PROJECT: RSLEC EXHIBIT HALL DEMOLITION  
RFP# 2019-03

This addendum has been issued to answer questions brought up in and after the pre-bid meeting. This Addendum forms a part of the Contract Documents and modifies the original Bidding Documents dated January 15, 2019, as described below:

Addendum 2 to RFP 2019-03 is a clarification of the work that is required by the RSCVA for the demolition of the Exhibit Hall.

## BOLLARD DETAIL

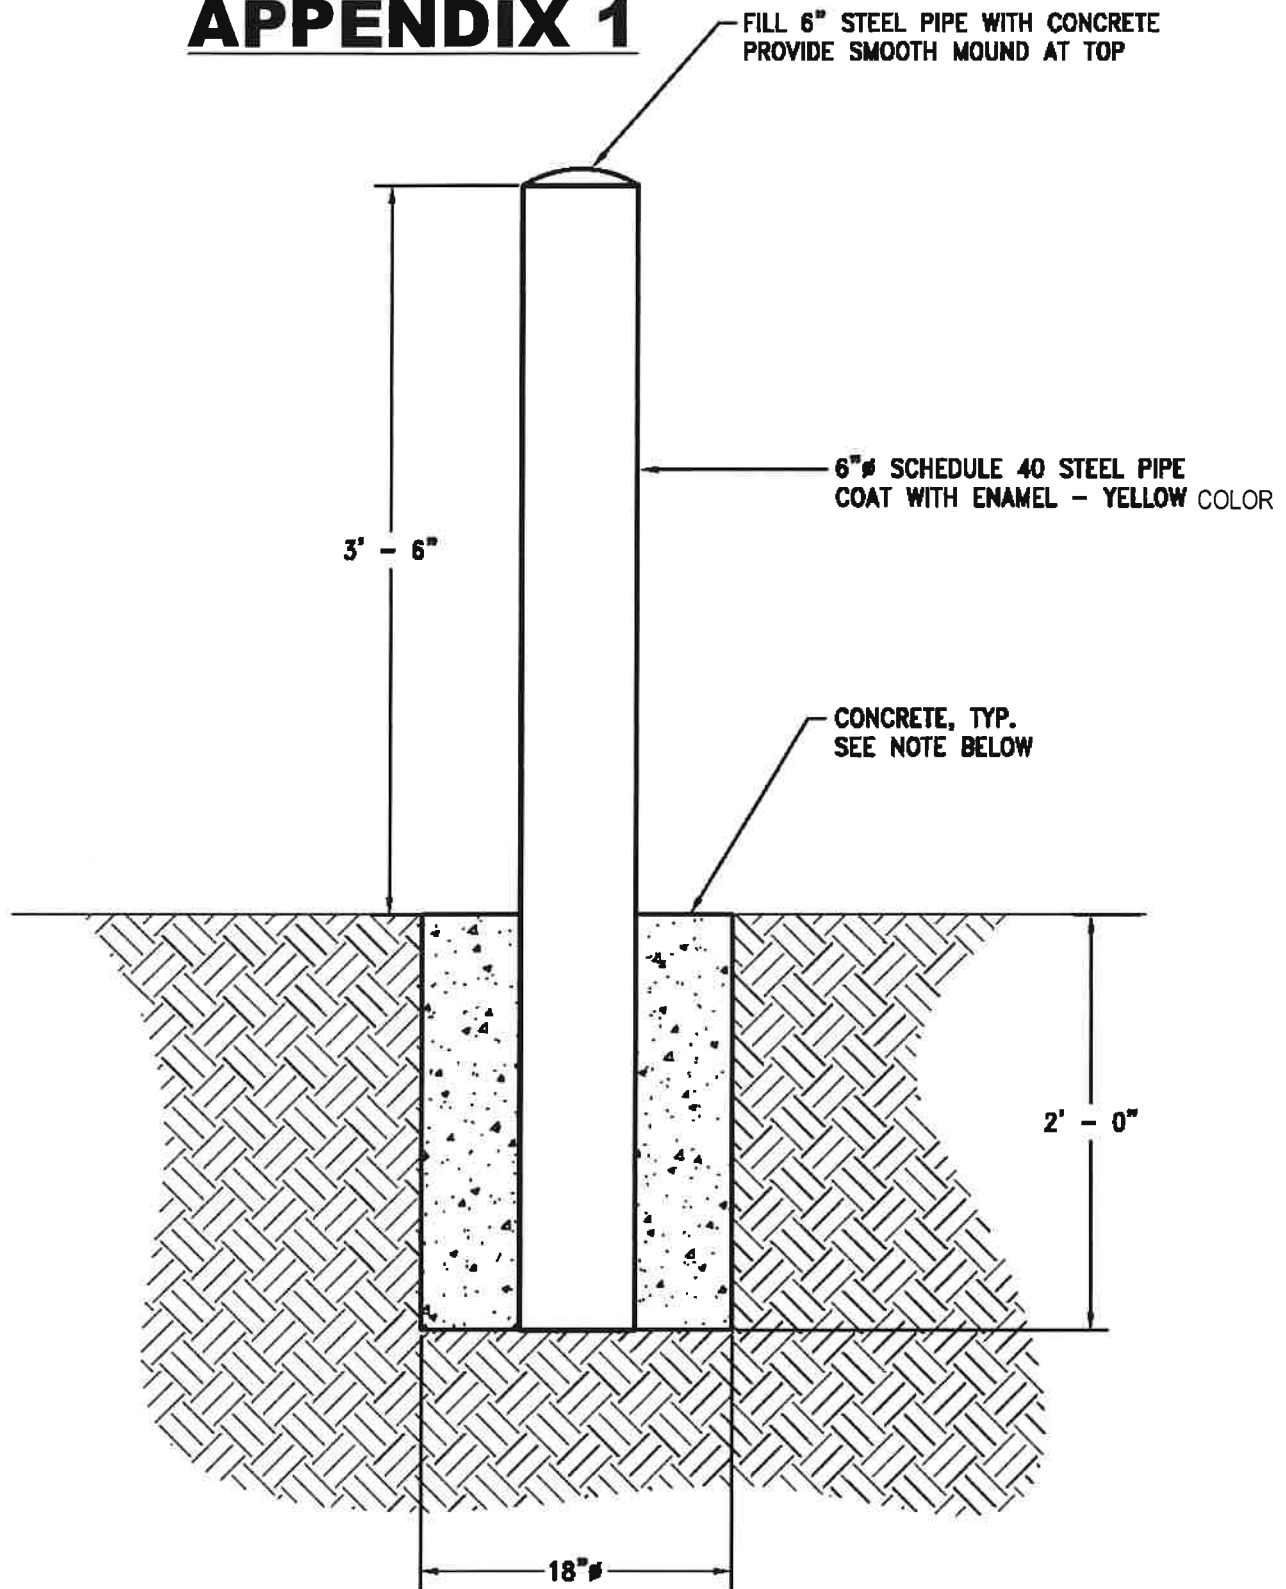
It is required that four bollards per utility area be installed to protect the electrical and water on the east and west side of the Exhibit Hall as it is currently configured. A total of thirty-two bollards are needed for this project. See Appendix 1 for installation requirements.

PORTLAND CEMENT CONCRETE (CONCRETE) SHALL HAVE THE FOLLOWING CHARACTERISTICS: 3,000 PSI MINIMUM COMPRESSIVE STRENGTH AT 28 DAYS, MINIMUM 6 SACKS OF CEMENT PER CUBIC YARD, SLUMP AT 1 TO 4 INCHES.
